RE: Woodbury Apartments
Tract 17 Bulk Land Plat Tracts 1 through 18 Artiste, Mesa del Sol
Conceptual Grading and Drainage Plan
Engineer's Stamp Date: 1/27/2023
Hydrology File: R16D097C

Re: Comment Response Letter – Woodbury Apartments tract 17 Bulk Land Plat Tracts 1 through 18 Artiste, Mesa del Sol Conceptual Grading and Drainage Plan (Hydrology File: R16D097C)

CONCEPTUAL
GRADING EXHIBIT

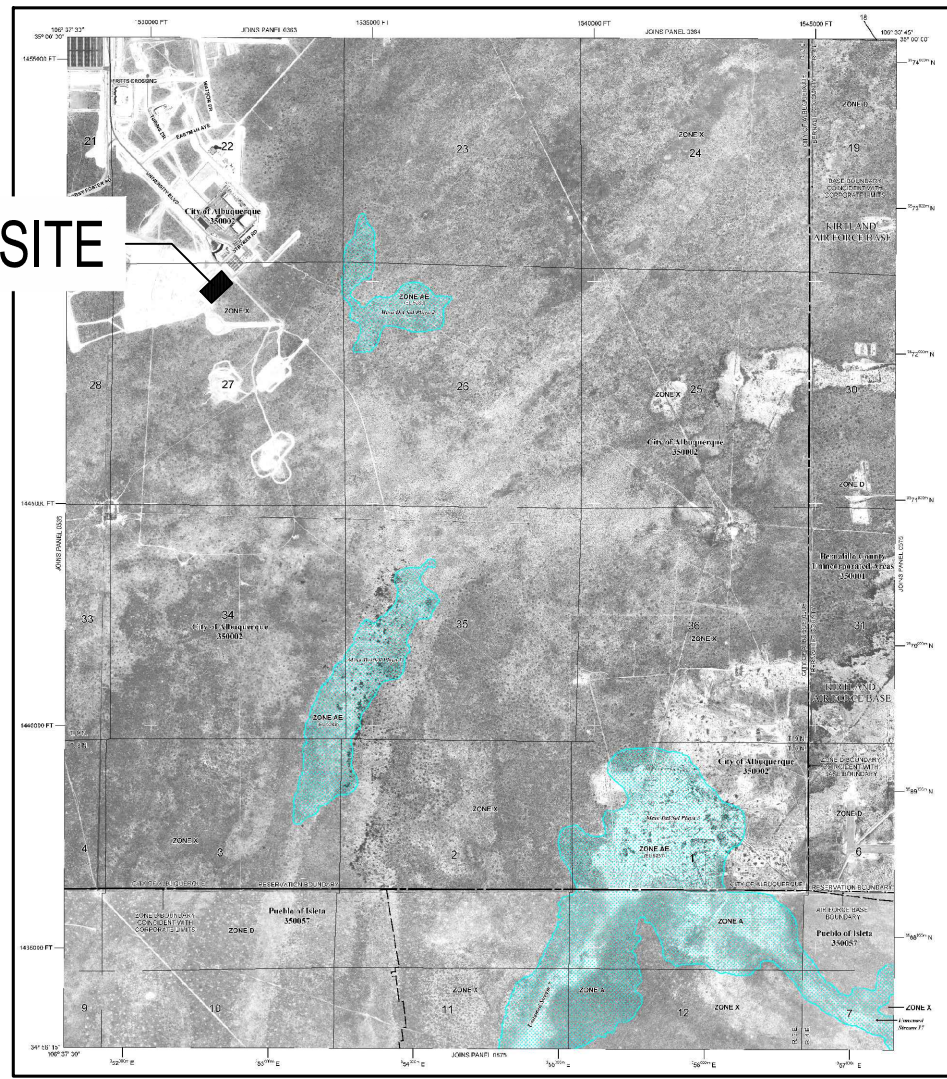
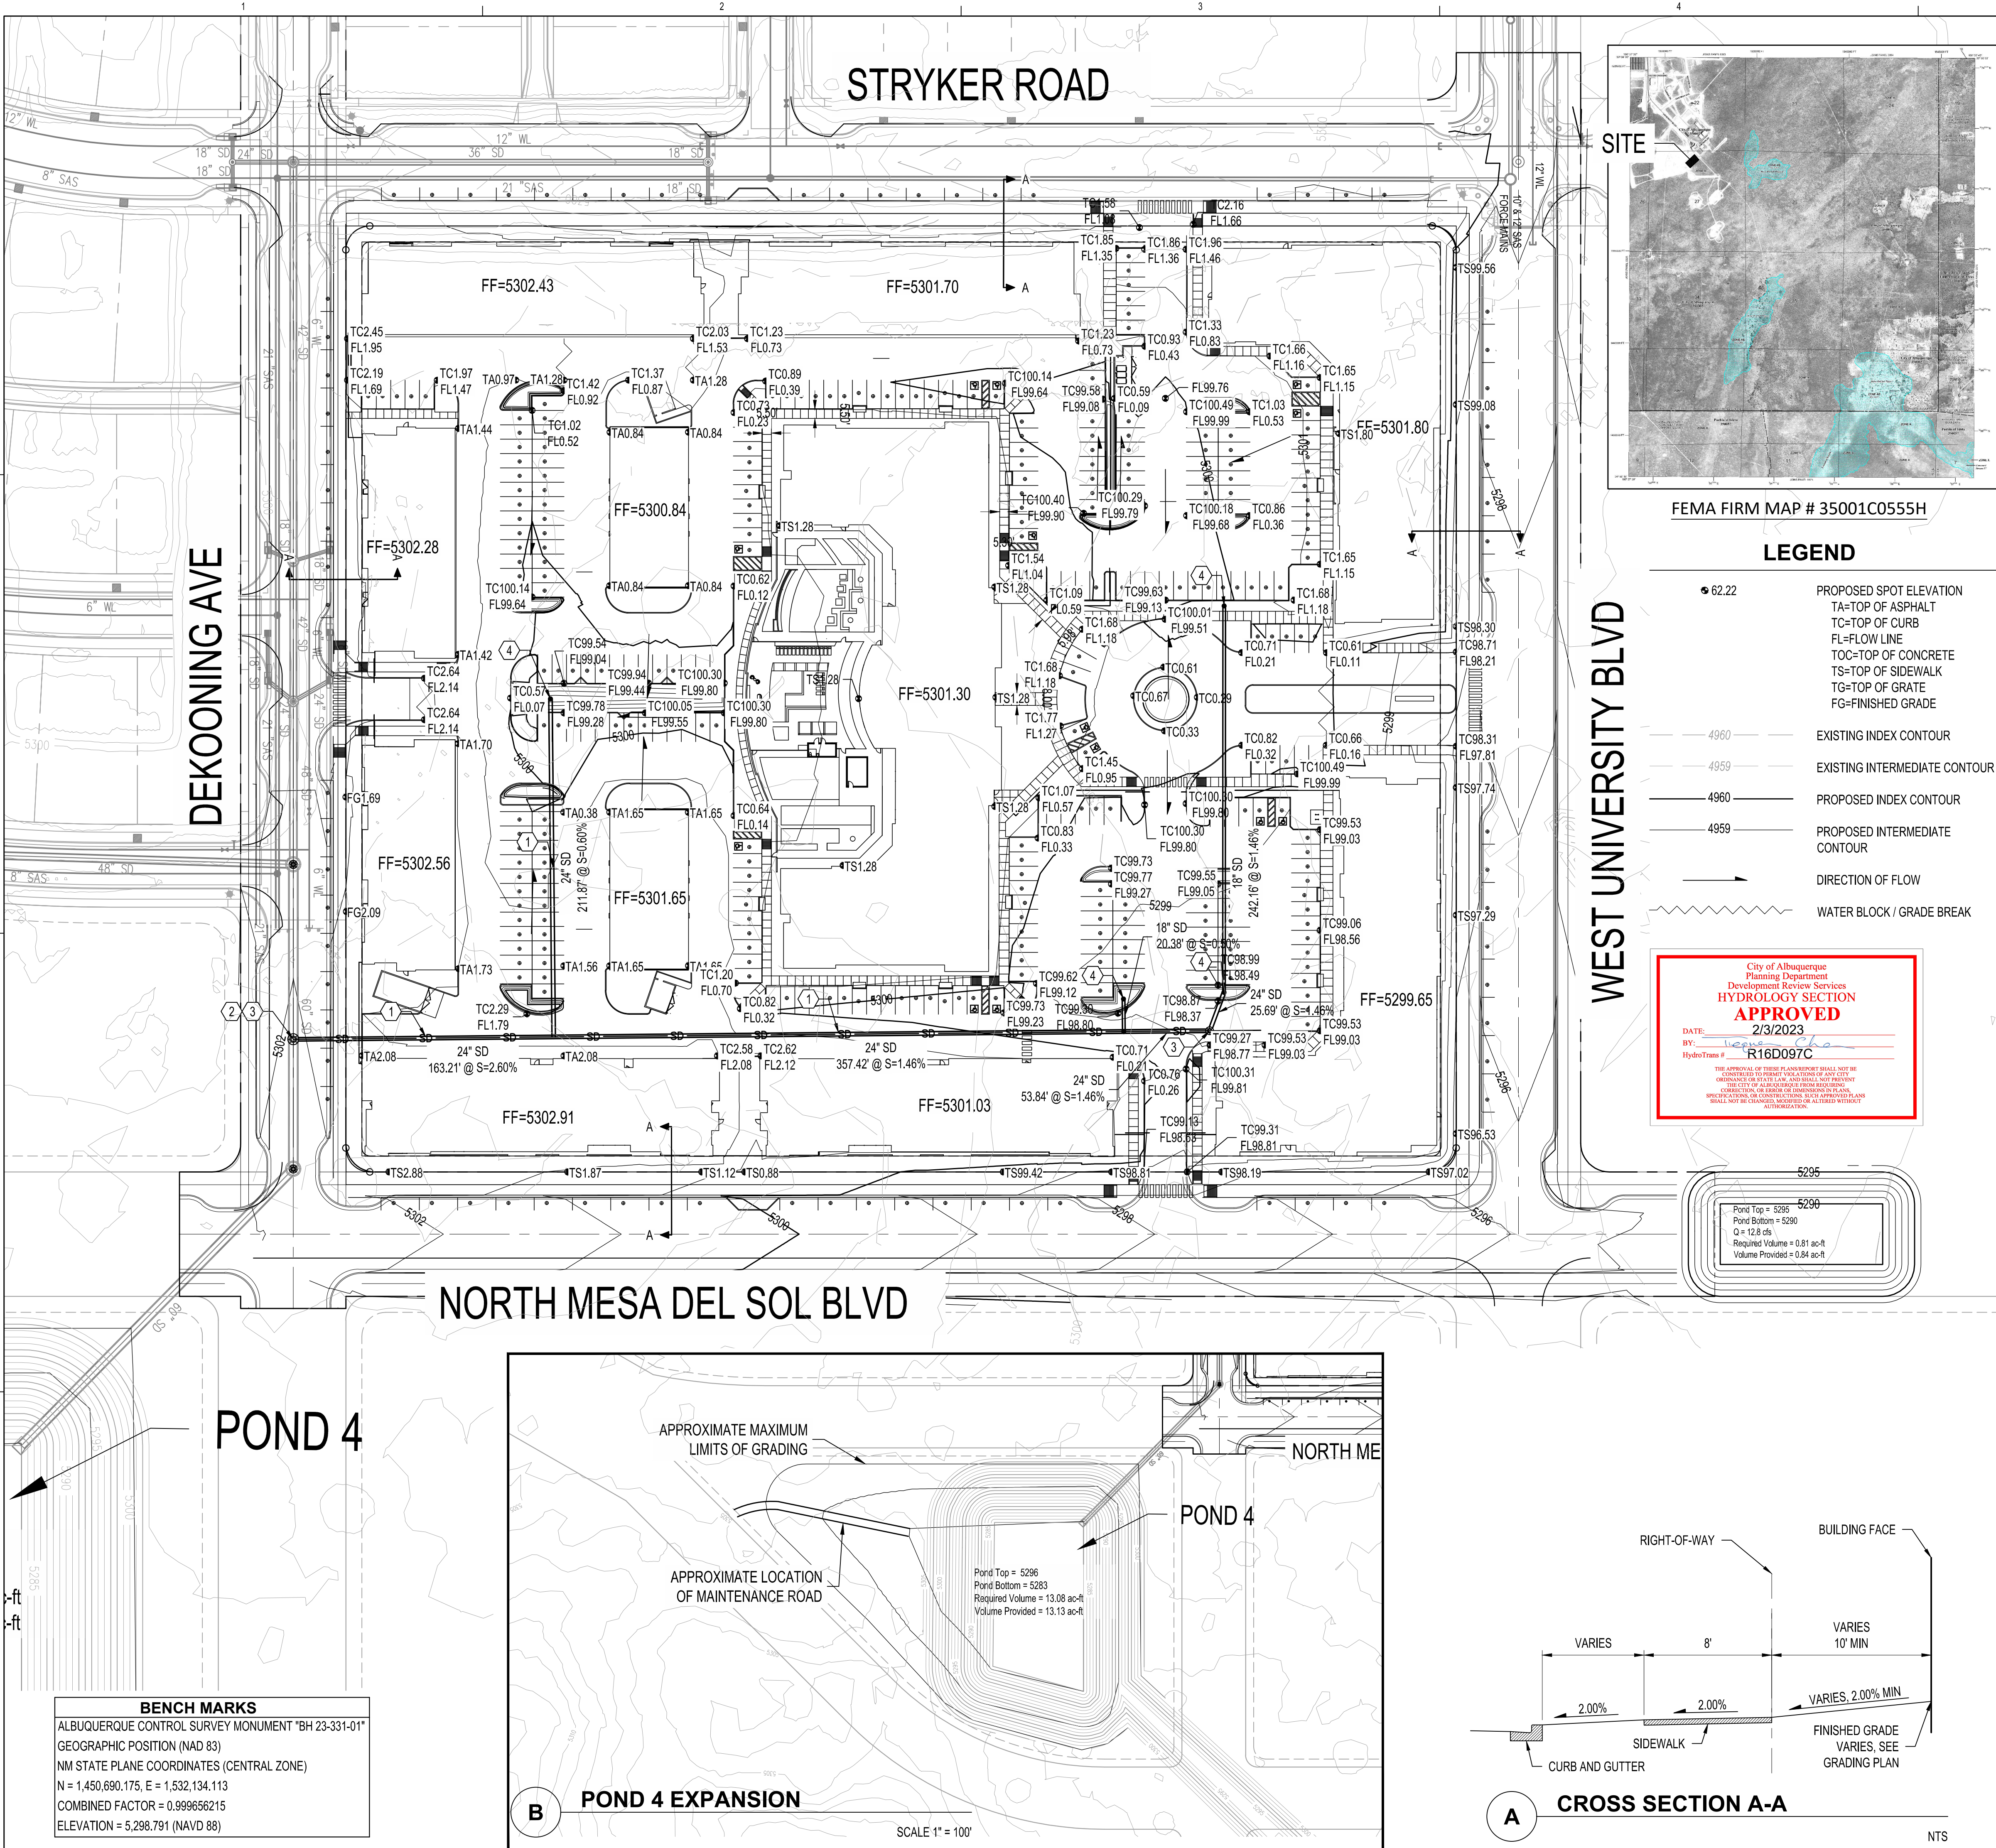
7. Is there DI missing at this location of the grading keyed note 4 should be changed to note 1 on sheet 1 of 1.

8. Move this label to show the proposed SD pipe on sheet 1 of 1.

9. Provide pond 4 revised size showing that it can accommodate the discharge generated from this development.

- ***Grading keyed note has been changed to note 1.***

- ***Label has been moved.***

- ***Pond 4 expansion information has been included in the Conceptual Grading Exhibit.***

CONCEPTUAL PROPOSED DRAINAGE EXHIBIT

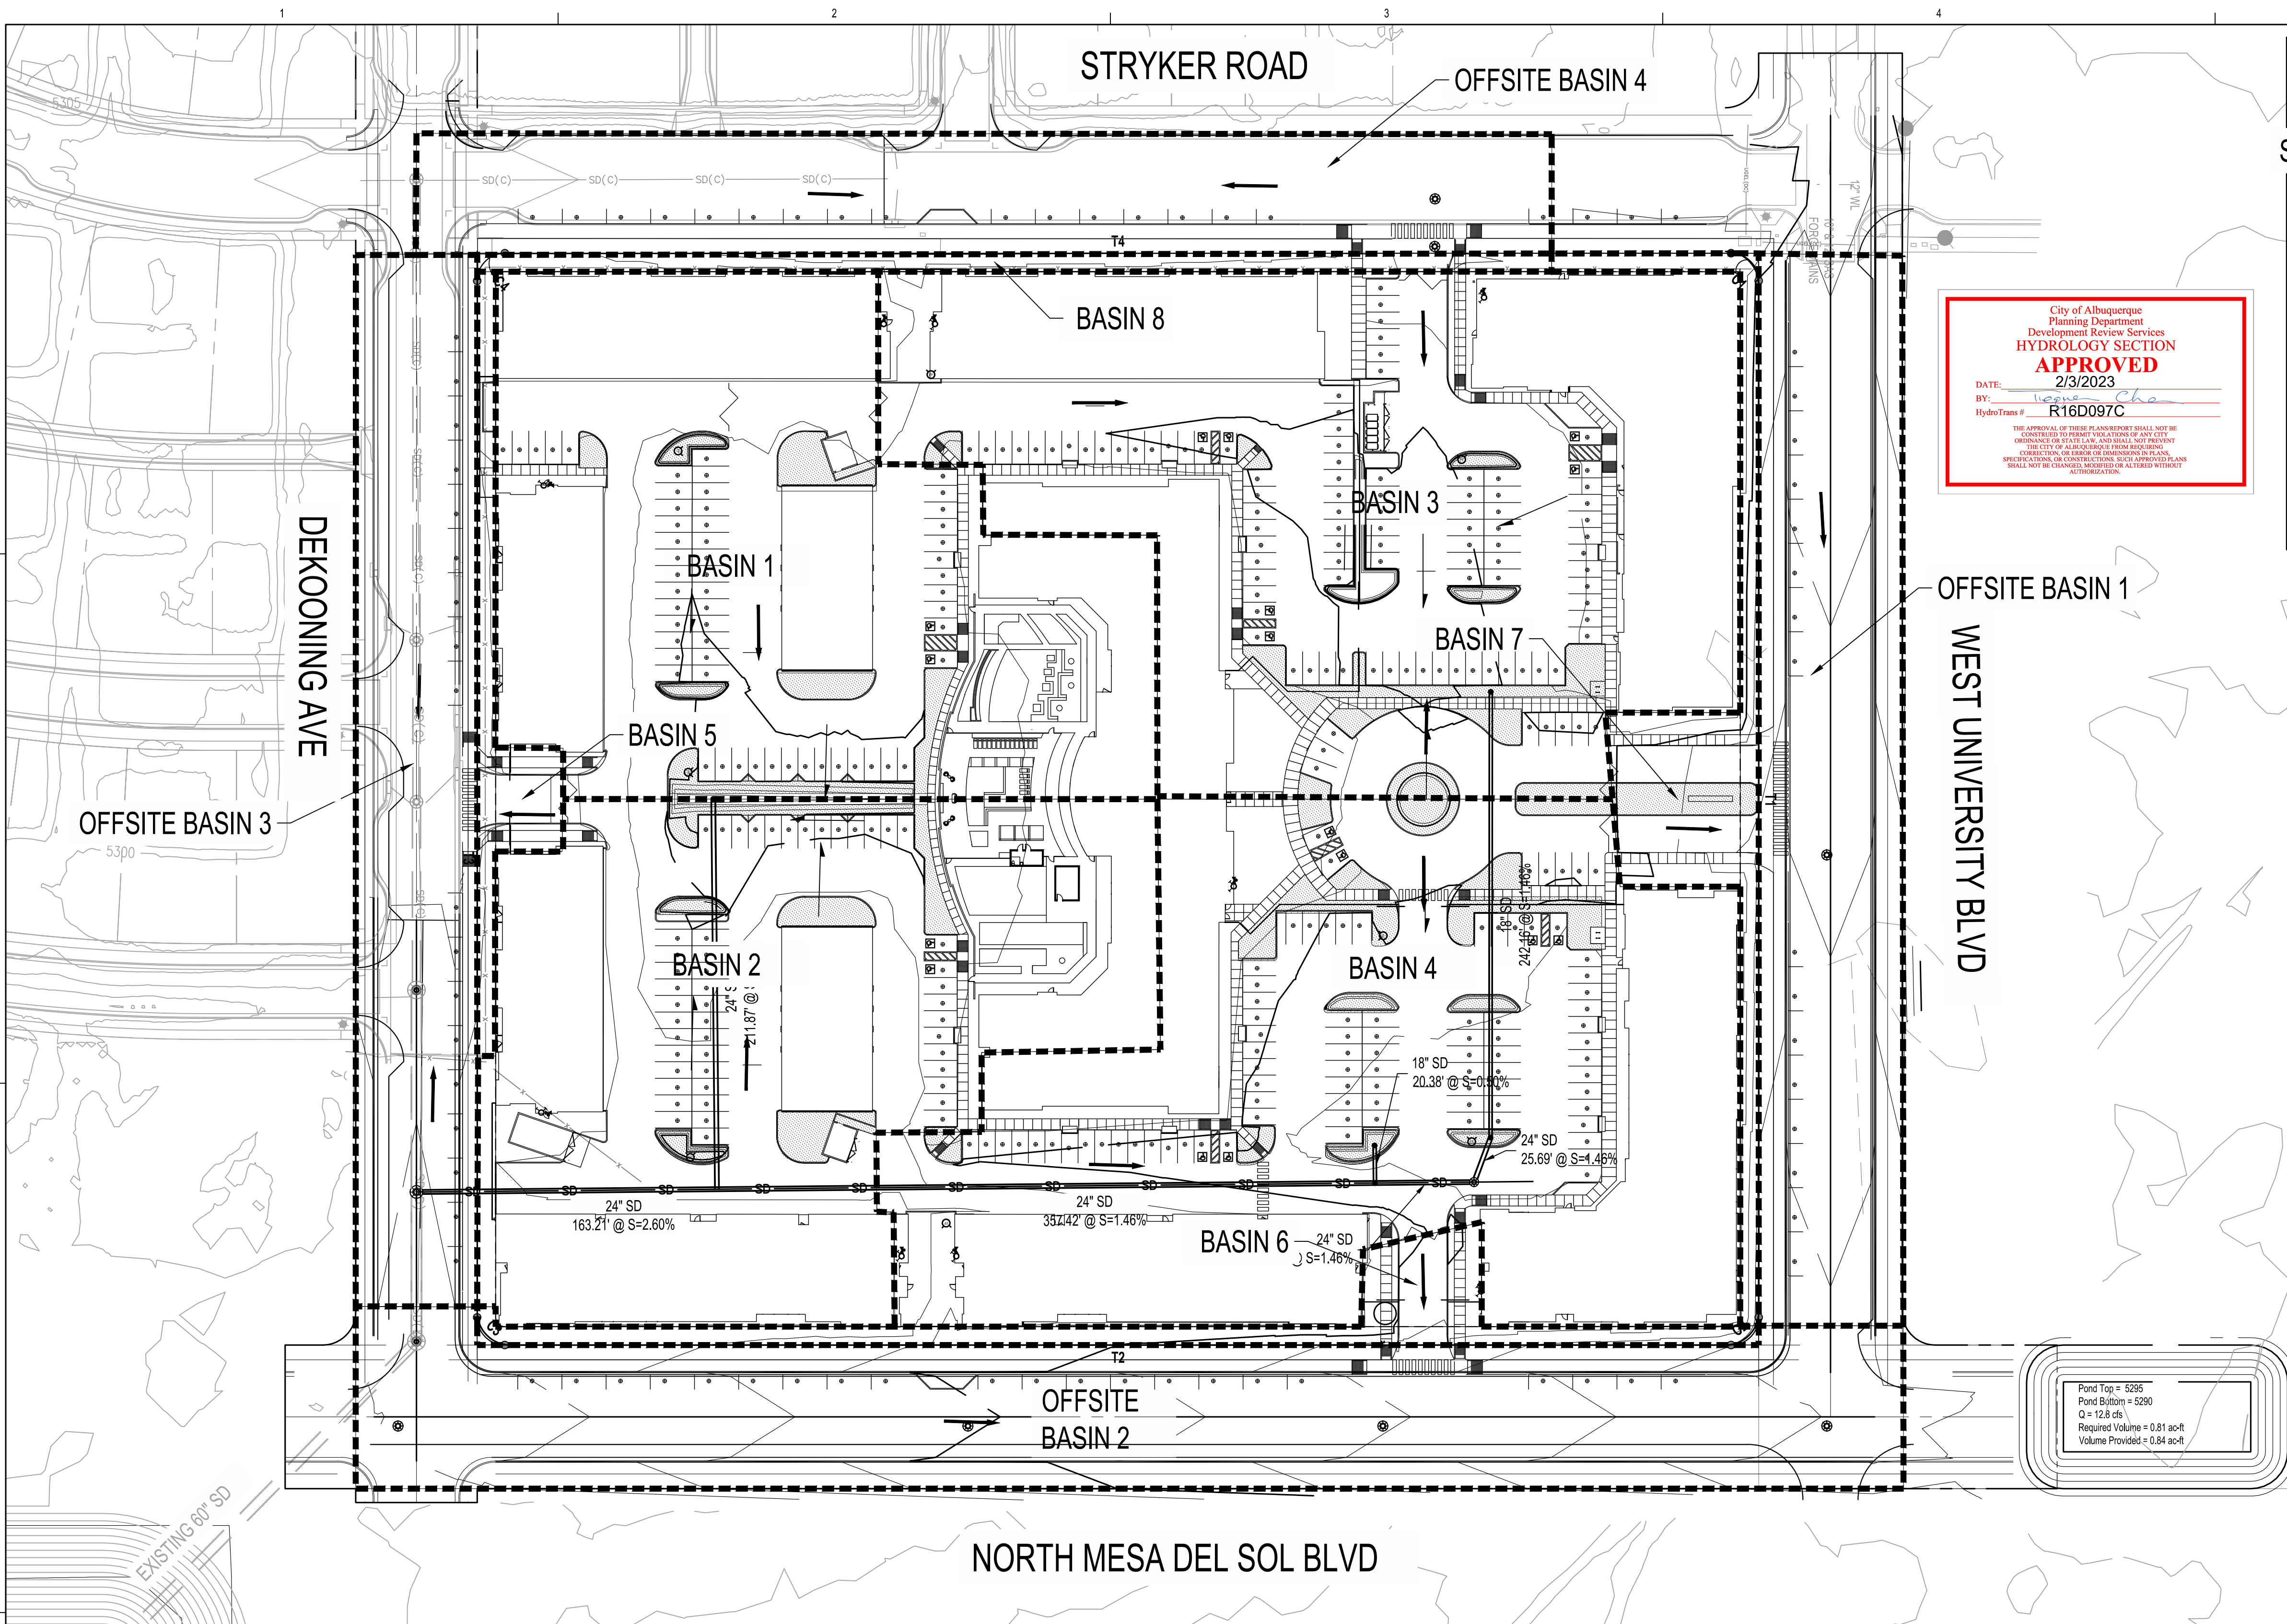
4. Add another column for the provided SWQV on the proposed conditions basin data table.
 - ***New column for SWQV has been added to the proposed conditions basin data table.***

6. Add proposed SD pipe size on the plan.

- ***Labels have been added for SD pipe sizes.***
